POWER PIPING REVISIONS

REACTOR COOLANT SYSTEM (RCS)
REACTOR CONTAINMENT
EL 718-6

JOB NO. 102-1
DWG. NO. 102-2-82
CND. AD. DATE 9-2-82

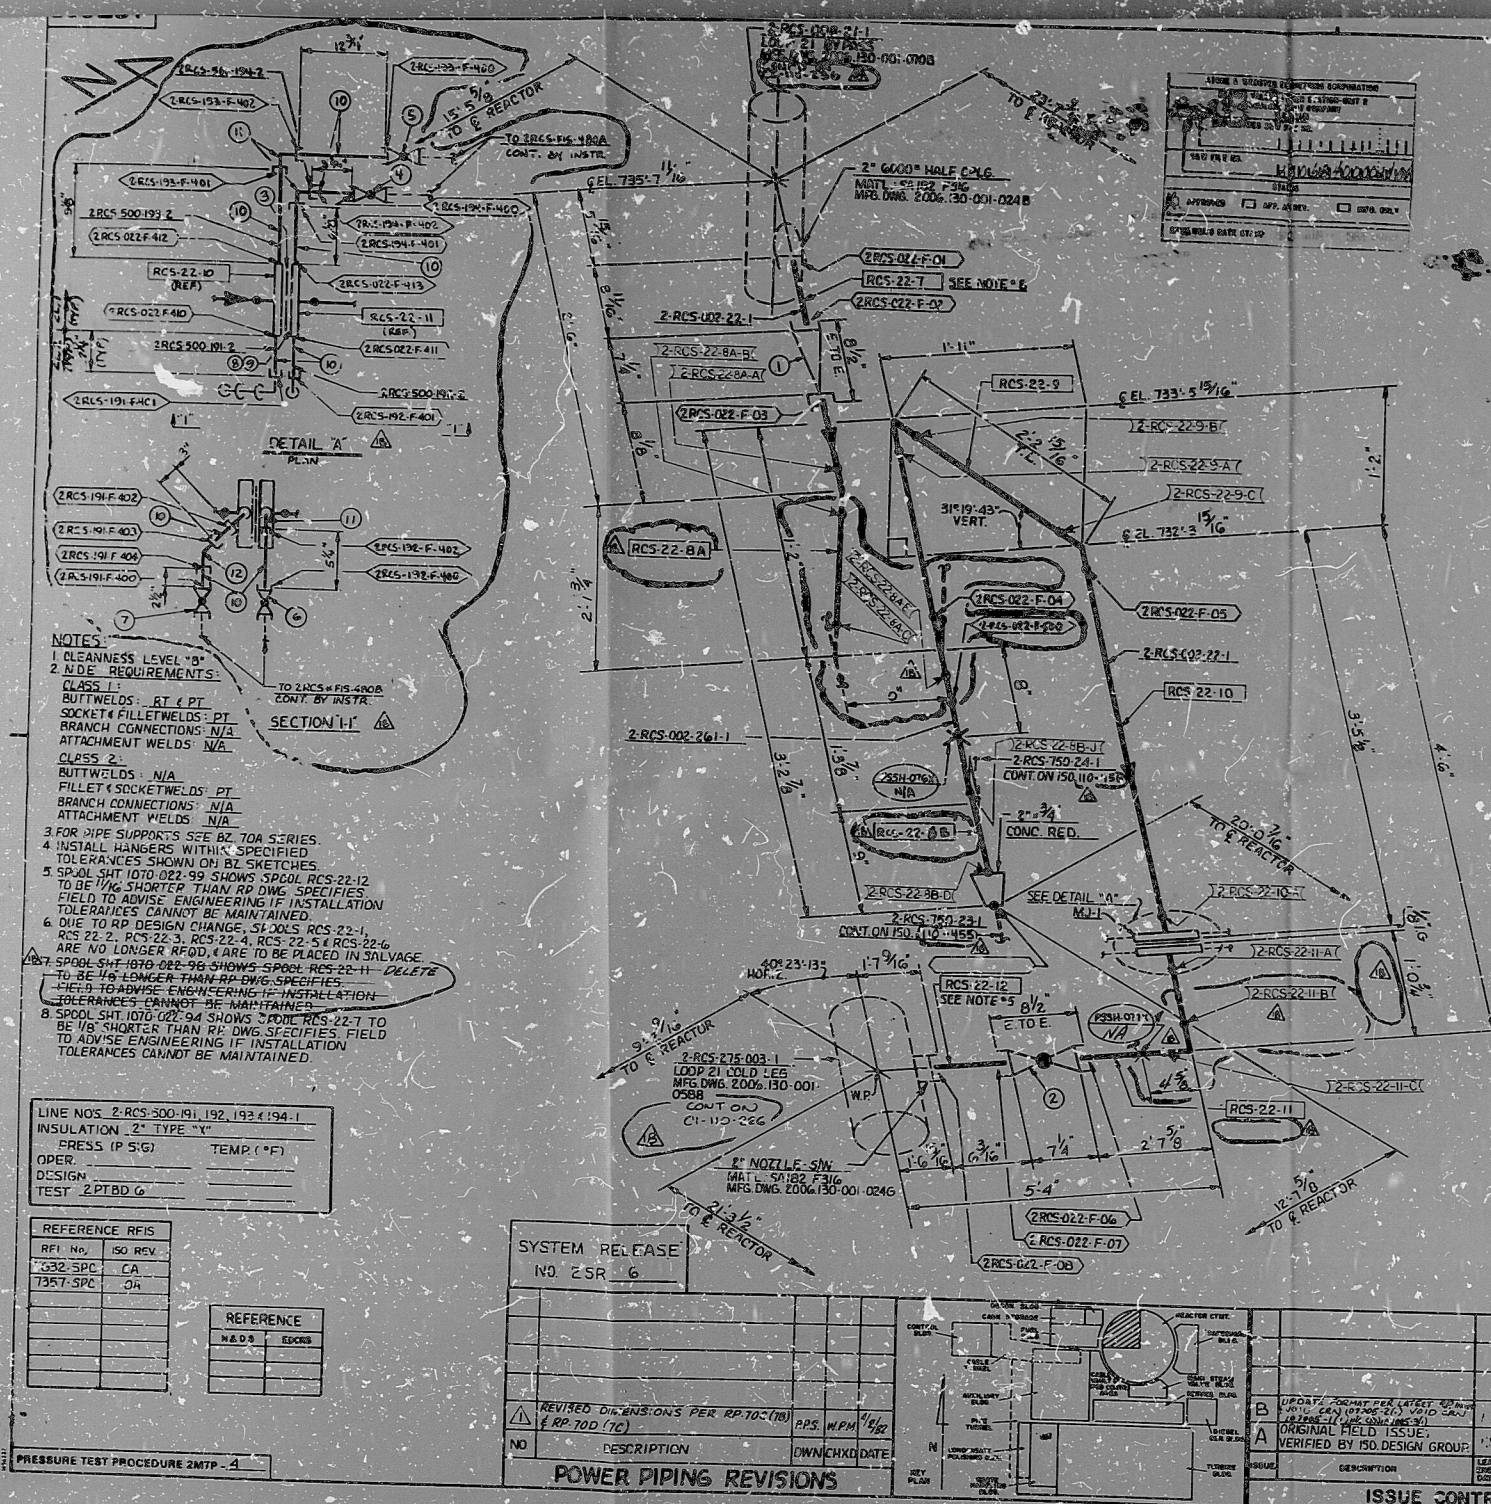
3. FOR PIPE SUPPORTS SEE BZ 70A SERIES.
4. INSTALL HANGERS WITHIN SPECIFIED TOLERANCES SHOWN ON BZ SKETCHES.
5. SPALL SHT 1070-022-99 SHOWS SPALL RCS-22-12 TO BE 1/8" SHORTER THAN RP DWG SPECIFIES. FIELD TO ADVISE ENGINEERING IF INSTALLATION TOLERANCES CANNOT BE MAINTAINED.

6. ONE TO RP DESIGN CHANGE, S1 DLS RCS-22-1, RCS-22-2, RCS-22-3, RCS-22-4, RCS-22-5 & RCS-22-6 ARE NO LONGER RFD. ARE TO BE PLACED IN SALVAGE.
7. SPALL SHT 1070-022-98 SHOWS SPALL RCS-22-11. DELETE TO BE 1/8" LONGER THAN RP DWG SPECIFIES. FIELD TO ADVISE ENGINEERING IF INSTALLATION TOLERANCES CANNOT BE MAINTAINED.

8. SPALL SHT 1070-022-94 SHOWS SPALL RCS-22-7 TO BE 1/8" SHORTER THAN RP DWG SPECIFIES. FIELD TO ADVISE ENGINEERING IF INSTALLATION TOLERANCES CANNOT BE MAINTAINED.

SEE NOTE 6

SEE NOTE 8

SEE NOTE 9
